EAW Comment – Impaired Access to ESC Public Data and Procedural Defects Affecting Public Participation

I am submitting this email and the attached correspondence as a **formal public comment** on the Environmental Assessment Worksheet (EAW) for the **East Side Corridor (ESC)** project.

EAW Comment – Noise Analysis Deficiencies / Procedural Compliance

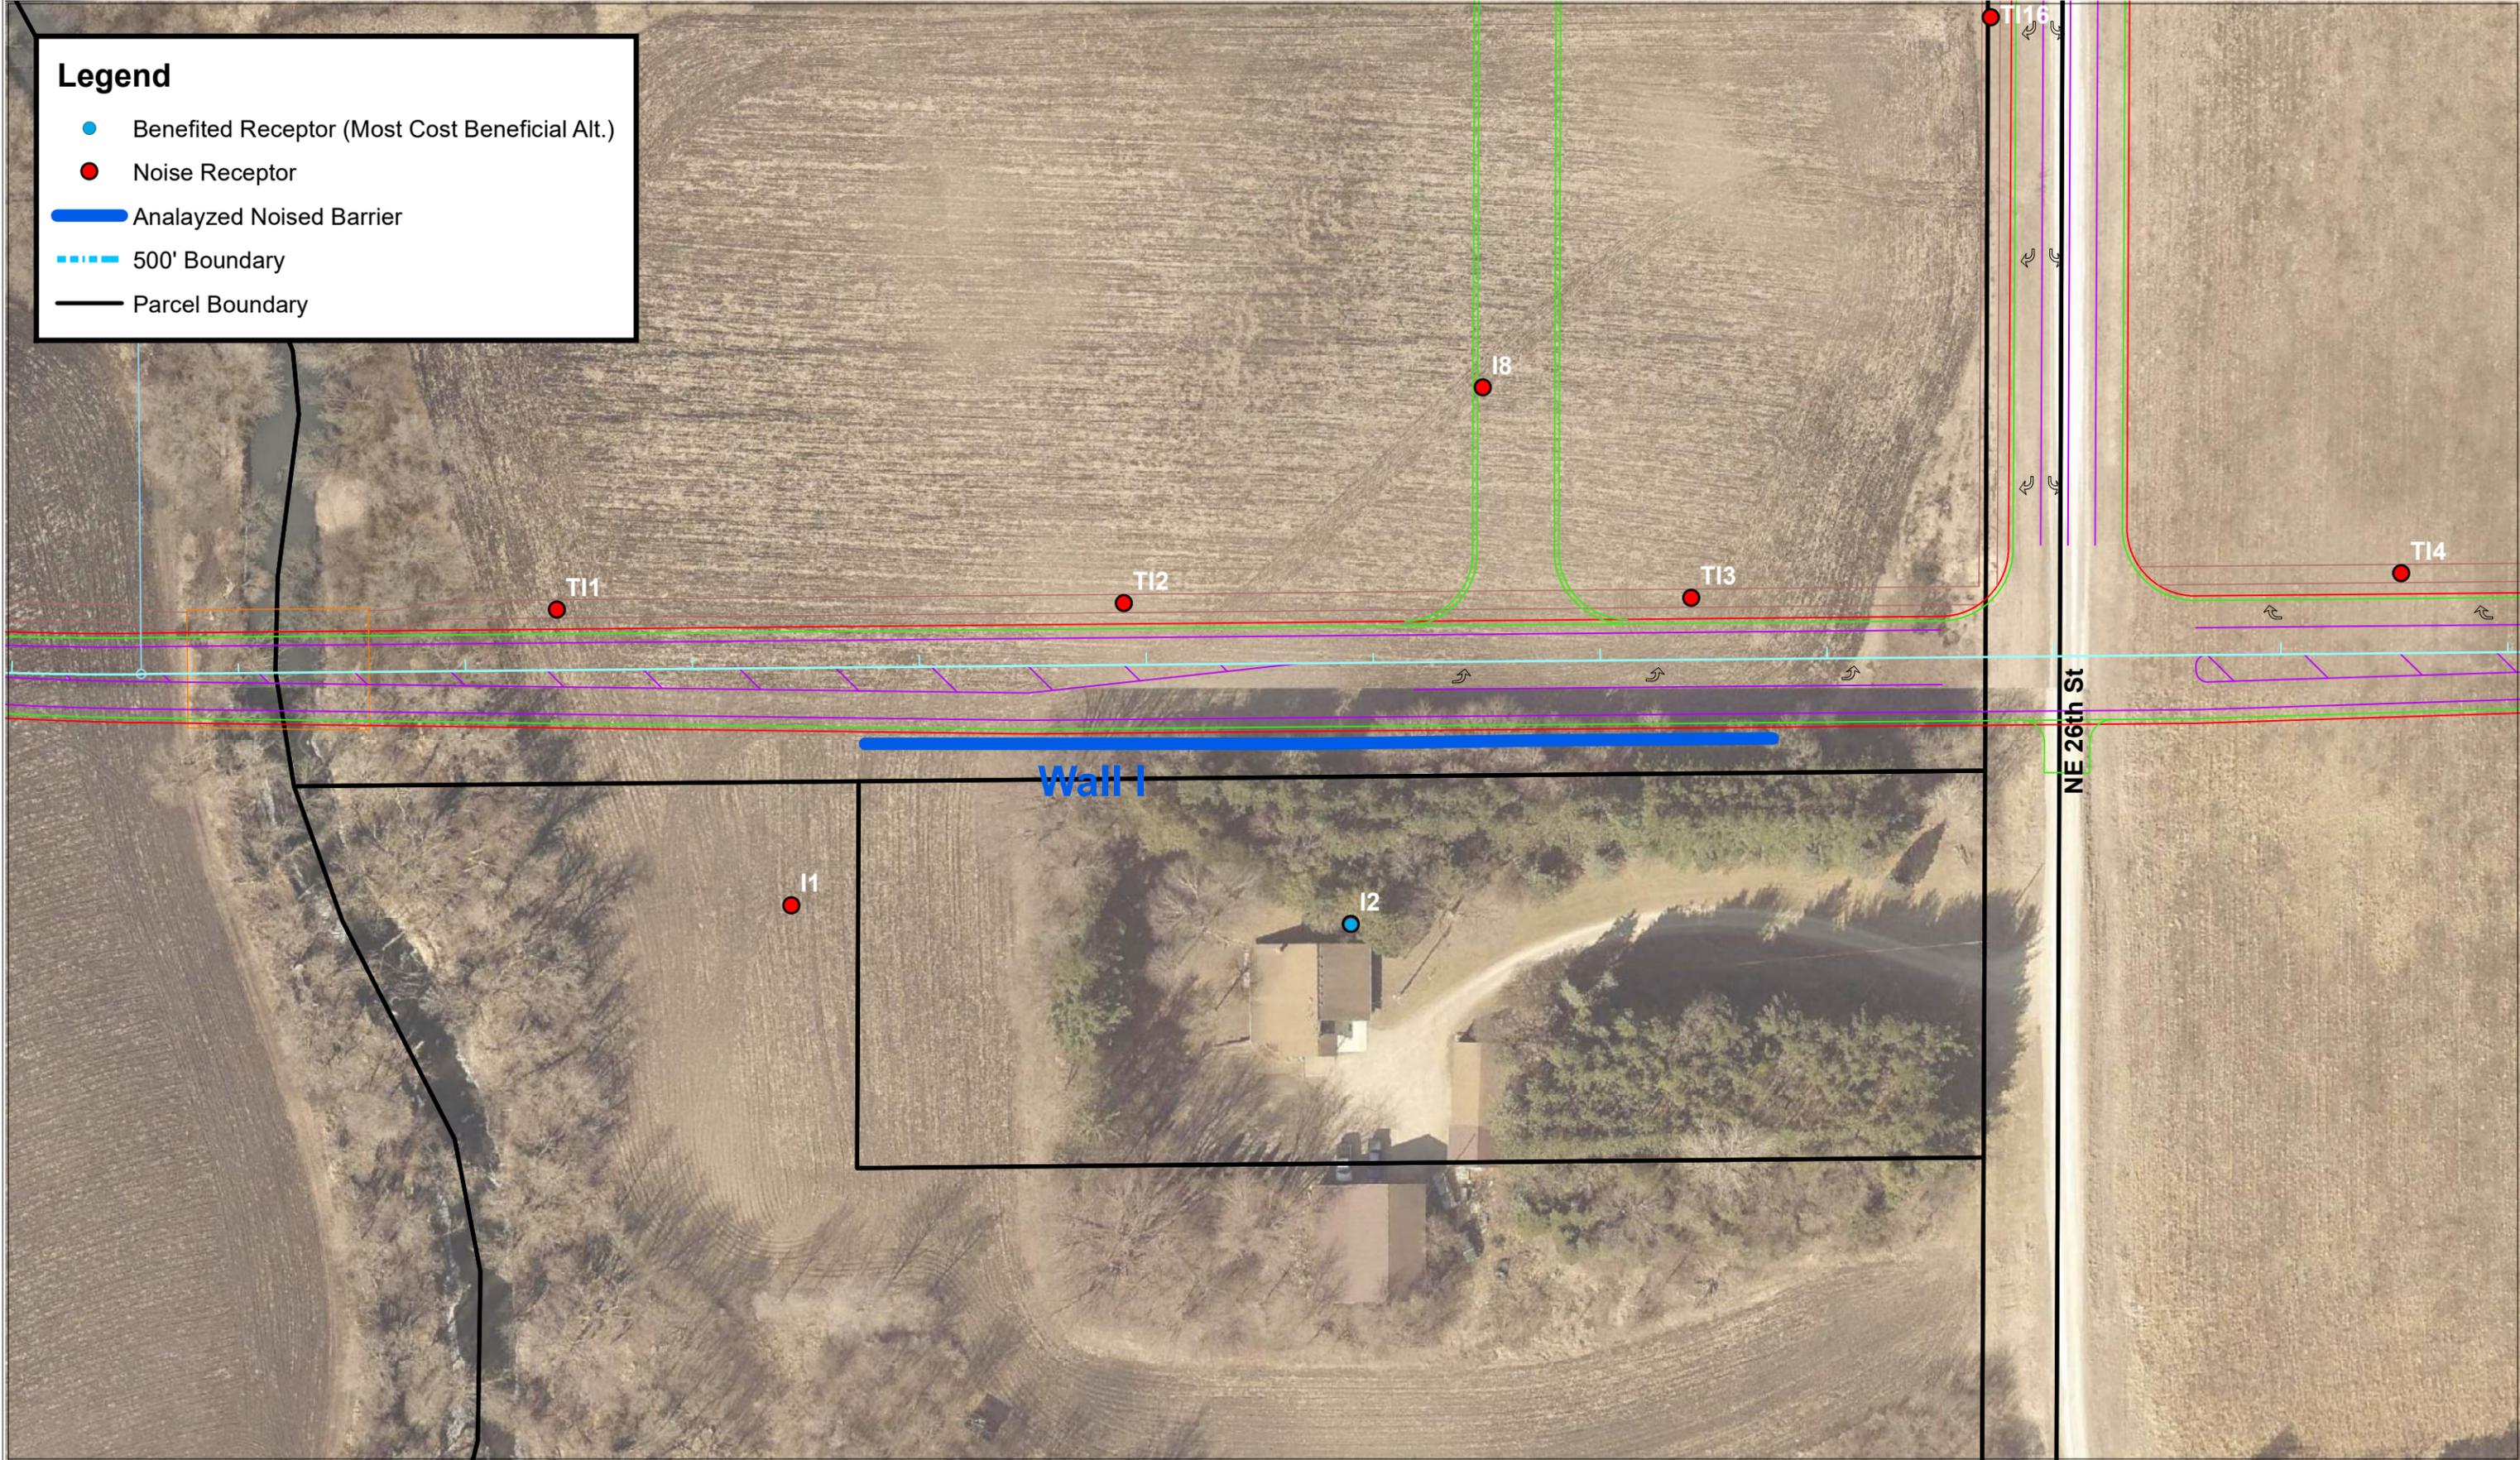
Additional figures dated **December 8 and December 14, 2024** show mitigation configurations in which **all adjacent residential properties** would experience at least **7 dBA reduction**, with an extended wall alignment wrapping the subdivision.
